Ref:	NR/L2/ELP/27009/MOD C01
Issue:	1
Date:	03/12/2011
Compliance date:	03/03/2012
Page	1 of 4

OVERHEAD LINE CAMPAIGN CHANGES – DATA SHEET

REPLACEMENT OF CAM TYPE 753 COPPER LOOP DROPPERS

Item 753

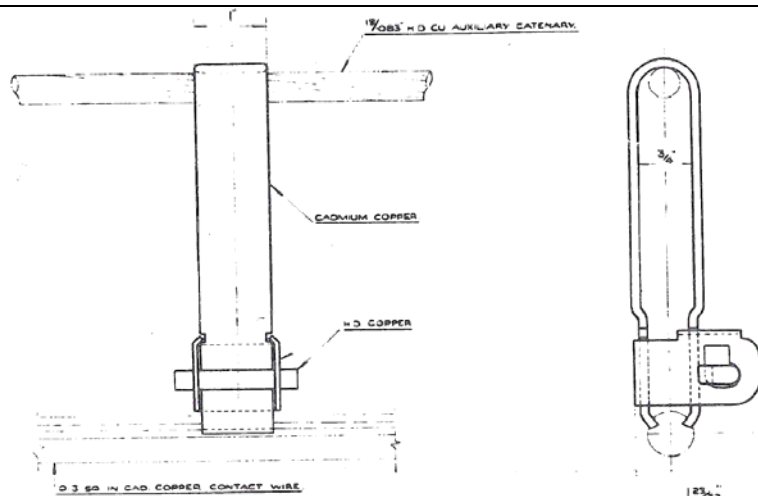
PROBLEM These loop droppers can come loose from the contact wire, allowing them to move along track and foul pantographs.

Replace 80, 82 and 753 copper loop droppers with bolted copper loop droppers to OLEMI drawing 1/997/044. The replacement droppers have the following OLEMI references:
